<p>VOLLMER DRAINAGE IMPROVEMENTS 115 KV LAYOUT, GRADING, & DRAINAGE DETAILS TRI-STATE GENERATION & TRANSMISSION ASSOCIATION, INCORPORATED</p>	7	NO.	DATE	APPD.	REV.	M.F.
	6					
	5					
	4					
	3					
2						
1

S1150-A-01-011

ORIFICE PLATE AND TRASH RACK DETAILS AND NOTES

1. ALL SAFETY GRATES SHALL BE MOUNTED USING STAINLESS STEEL HARDWARE AND PROVIDED WITH HINGED AND LOCKABLE OR BOLTABLE ACCESS PANELS.
2. SAFETY GRATES SHALL BE STAINLESS STEEL, ALUMINUM, OR STEEL. STEEL GRATES SHALL BE HOT DIP GALVANIZED AND MAY BE HOT POWDER COATED AFTER GALVANIZING.

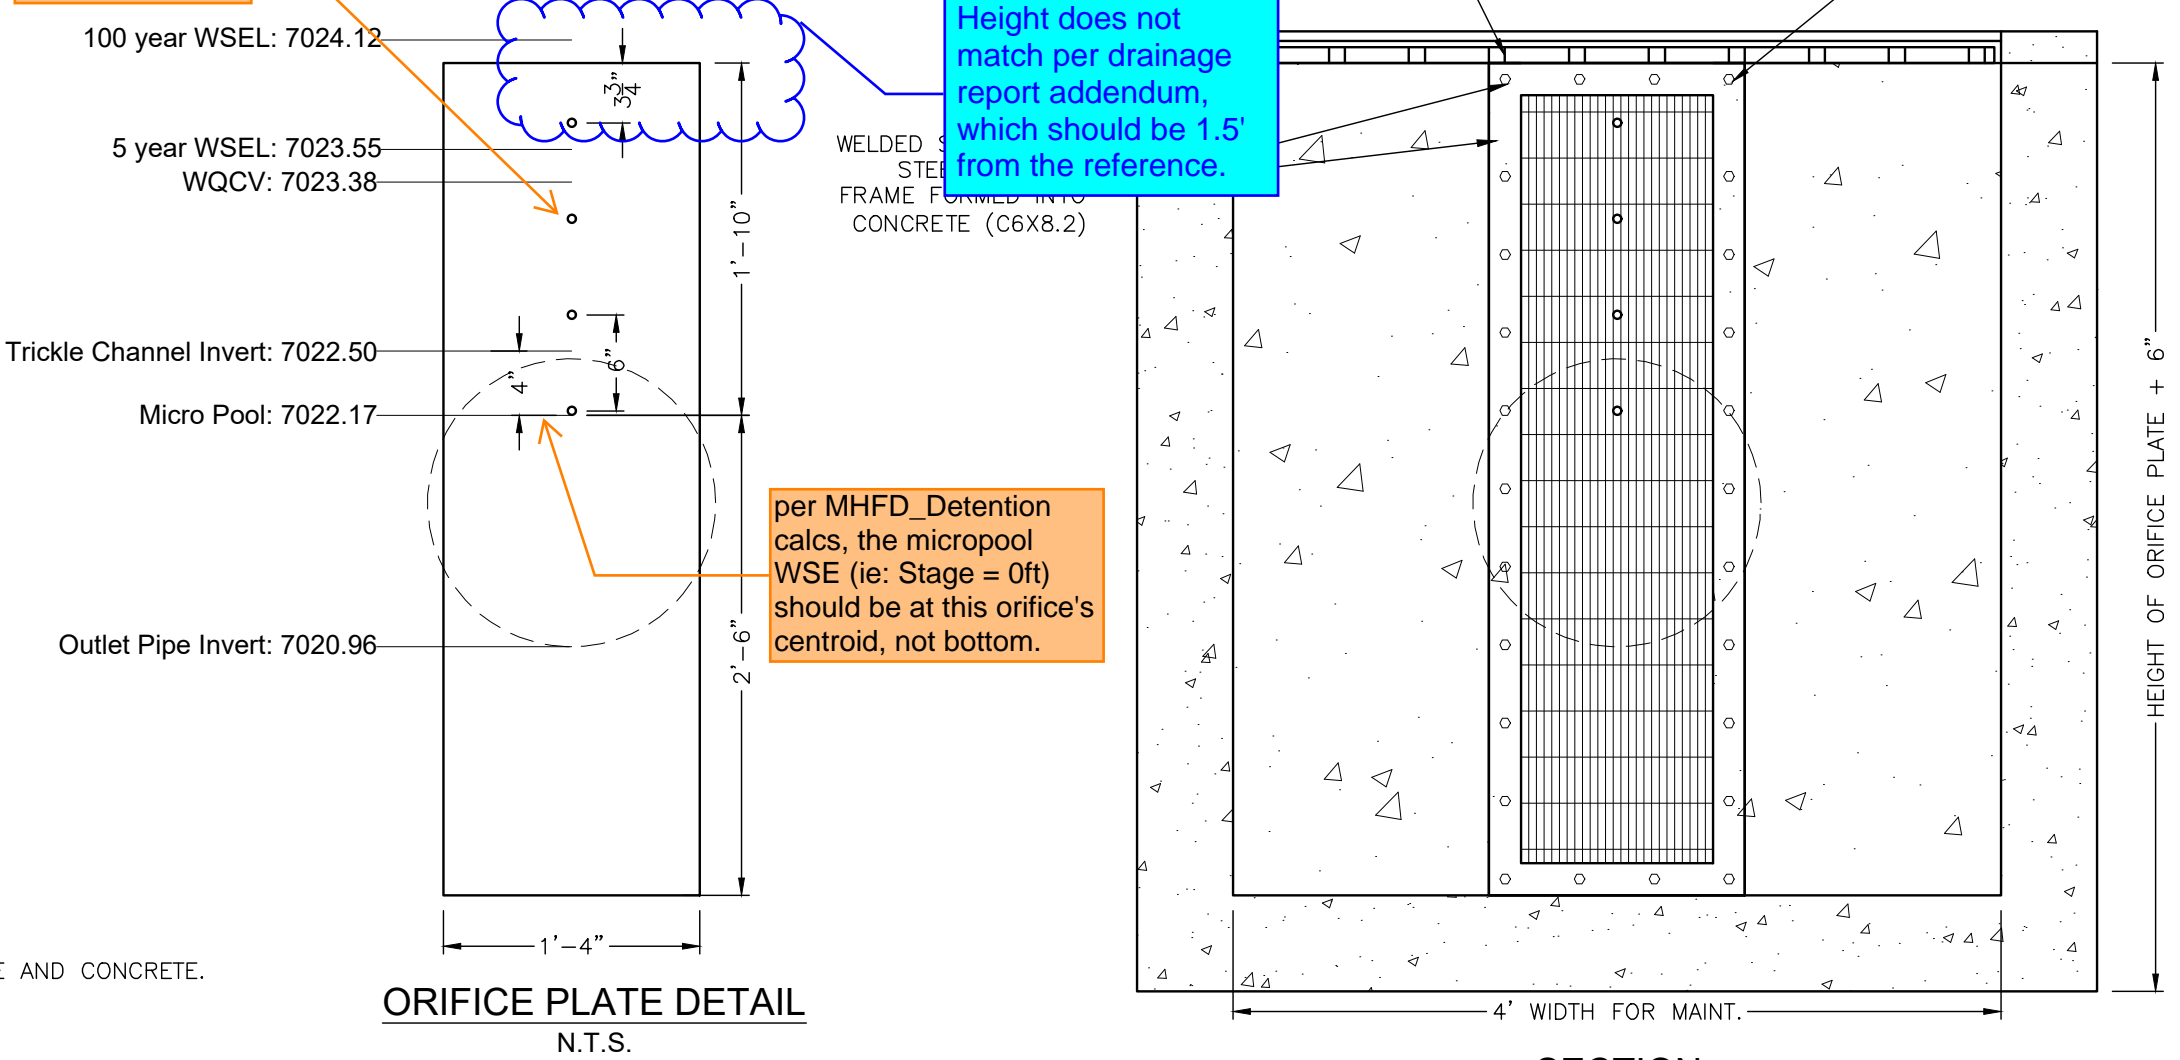
label diameter of all orifice (0.5" per calcs)

Recommend capping the top of this opening to prevent debris from getting in between microscreen and orifice plate.

Height does not match per drainage report addendum, which should be 1.5' from the reference.

per MHFD Detention calcs, the micropool WSE (ie: Stage = 0ft) should be at this orifice's centroid, not bottom.
